STATE OF MAINE
DEPARTMENT OF HUMAN SERVICES
AUGUSTA, MAINE 04333

August 25, 1988

Subject: Replacement System Variance for Holding Tank installation,
Courtenay property, 1355 Hayden Road, Augusta

SUBSURFACE WASTEWATER DISPOSAL SYSTEM APPLICATION

SITE PLAN

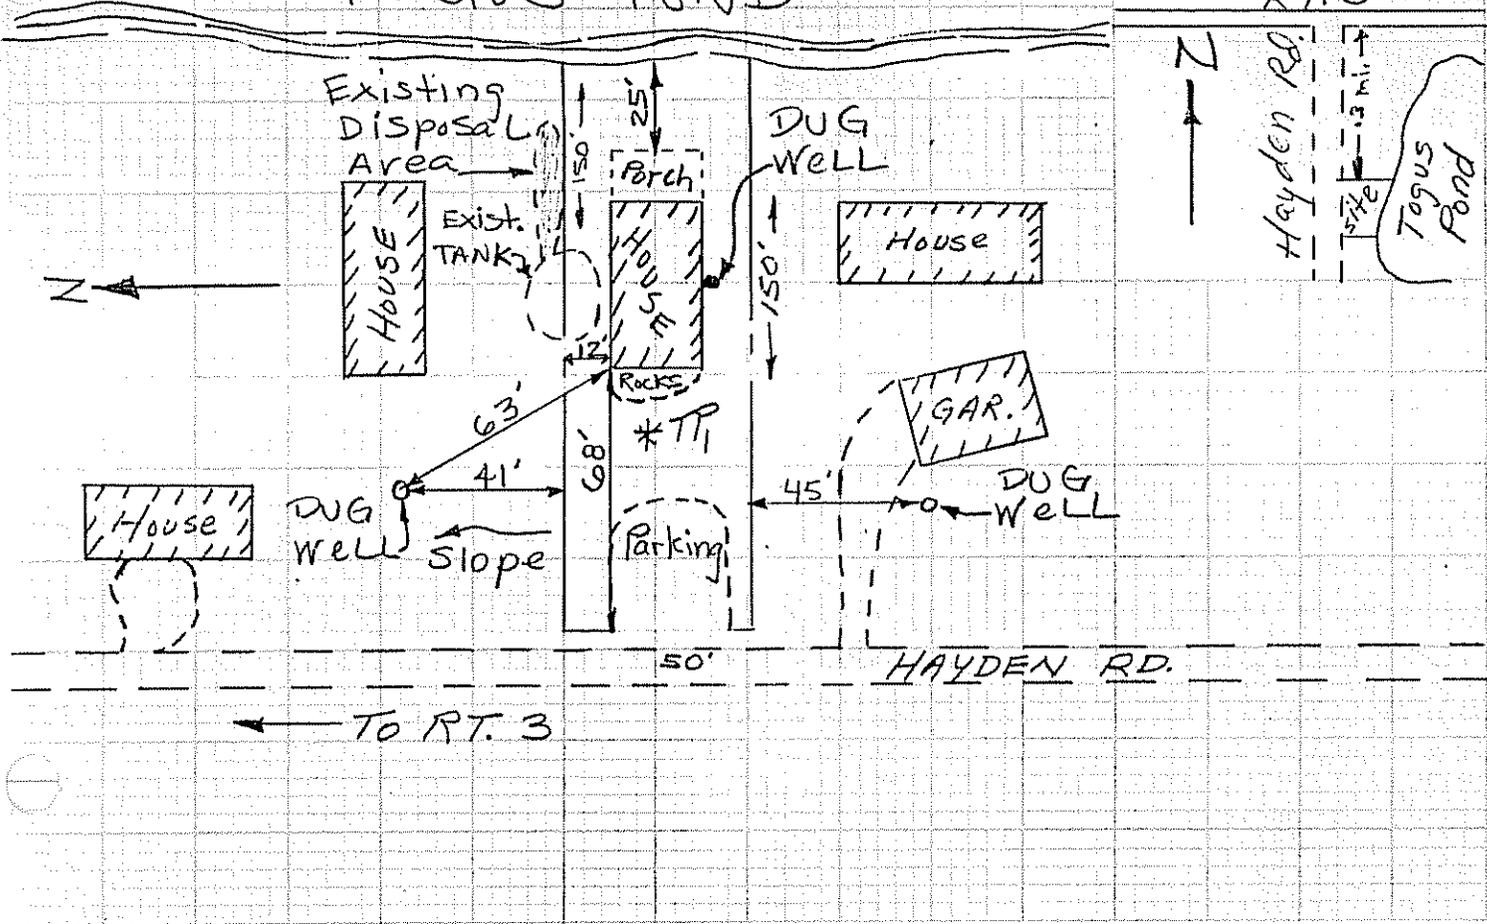
Texture	Consistency	Color	Mottling
Gravel	Friable	Brown	Mixing
FILL			
owner claims 4'+ of gravel fill over wet original ground. Shovel hole did not get to original Gd.

Texture	Consistency	Color	Mottling
DID NOT DARE TO PROPOSE DISPOSAL AREA DUE TO COARSE FILL, WET ORIGINAL SOIL AND LOCATION NEAR 3 DUG WELLS. OWNER FURTHER CLAIMS GROUND WATER ENTRY INTO FOUNDATION IN SPRING.

1. The installation of a 1500 gallon holding tank with suitable float alarm meeting the construction standards of CMR 241, Section 17.F.1.
2. The holding tank is to be used only on the existing single-family dwelling.
